# ***Smeaton Grange Waste Recycling & Transfer Facility***

*State Significant  
Development  
Modification Assessment  
(SSD 7424 MOD 1)*

September 2018

**Figure 3** | Proposed Modifications

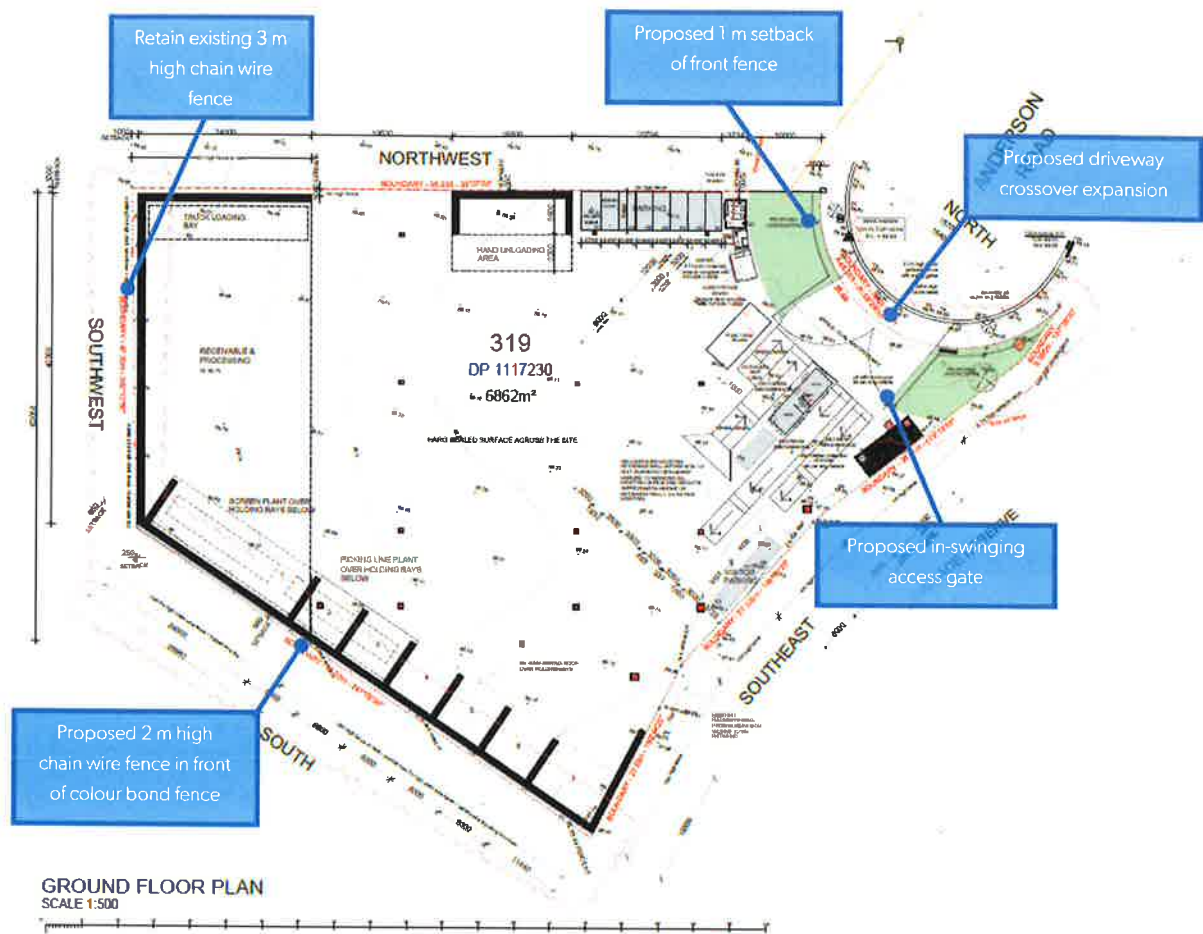
The proposed modification seeks to relocate the front metal palisade security fence and entry gate to be 1 m off the front boundary, retain the existing chain wire security fence on the south-western boundary and replace approved palisade fence with chain wire security fence on southern boundary. Council raised concerns with the proposed metal palisade front fence during the assessment of the original SSD 7424 application and requested the Applicant install a combination decorative metal and masonry fence. Consequently, Condition B61 was imposed on the consent requiring the design of the front security fence and gate to be constructed to Council's satisfaction prior to the issue of a Construction Certificate. Subsequently, this modification additionally seeks the deletion of condition B61 to remove Council's approval role regarding the fence.

Council raised concern that the construction of a palisade fence would not effectively screen the development from the street. Council's preference is for the front security fence to be a decorative masonry fence to effectively screen the development from the street. Council additionally supported the deletion of Condition B61 as Council deems the wording of the Condition as inappropriate as Council should not hold an approval role as the Minister for Planning is the consent authority. Council provided no comment on the proposed chain wire security fencing along the southern and south-western boundary.

The construction of the 2.1 m high front palisade security fencing and gate to be 1 m from the front boundary is compliant with Part D Section D4.2.5 Fencing of the CDCP 2011 and consistent with the objectives of the industrial controls of the CDCP 2011. The Department considers that the proposed fencing is consistent with the fencing on the Anderson Road street frontage and greater Smeaton Grange industrial precinct in general, allowing for visual surveillance to the street frontage and into the site. Furthermore, the requirement of decorative masonry fencing is considered to be onerous as clear lines of sight would still be visible between the street frontage and the sight during the approved hours for accepting waste deliveries and dispatch when gates are open for vehicle movements.

The retained vegetation buffer within the front setback and behind the 2.1 m metal palisade fence will contribute to the visual screening of the site to mitigate visual impacts of the site. Therefore, the proposed modification has a negligible impact on the visual amenity of the existing industrial streetscape as it is consistent with both the developmental controls applicable and the industrial locality.
